Report of Staff Recommendation

Tennessee Technology Corridor Development Authority

File Number: 3-B-20-TOB

Request: BUILDING PERMIT

ES1.1

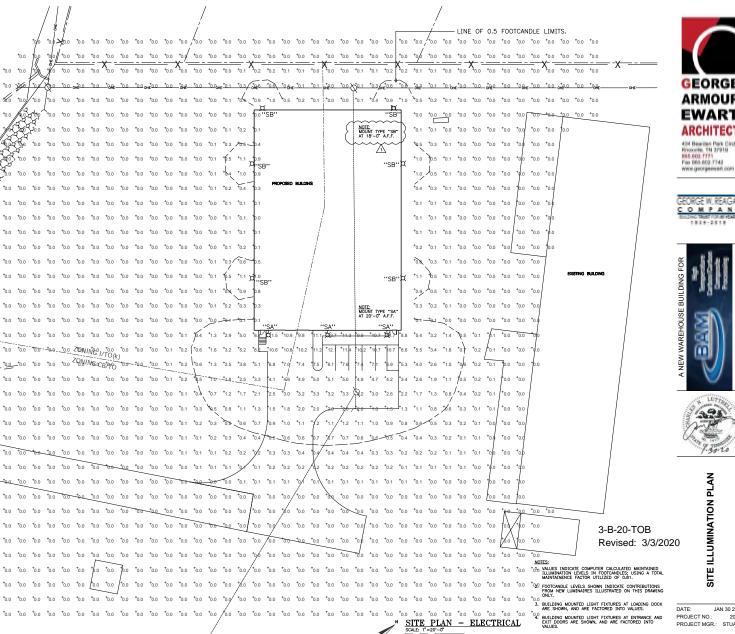
- 6. The proposed lighting for the parking lot and building includes full cut-off LED fixtures. The proposed site lighting still needs to be adjusted at the building entrances in order to fall within the maximum intensity limit of 5 foot candles.

- 4. Submitting a revised site lighting plan that adjusts the lighting at the building entrances in order to fall within the maximum intensity limit of 5 foot candles.
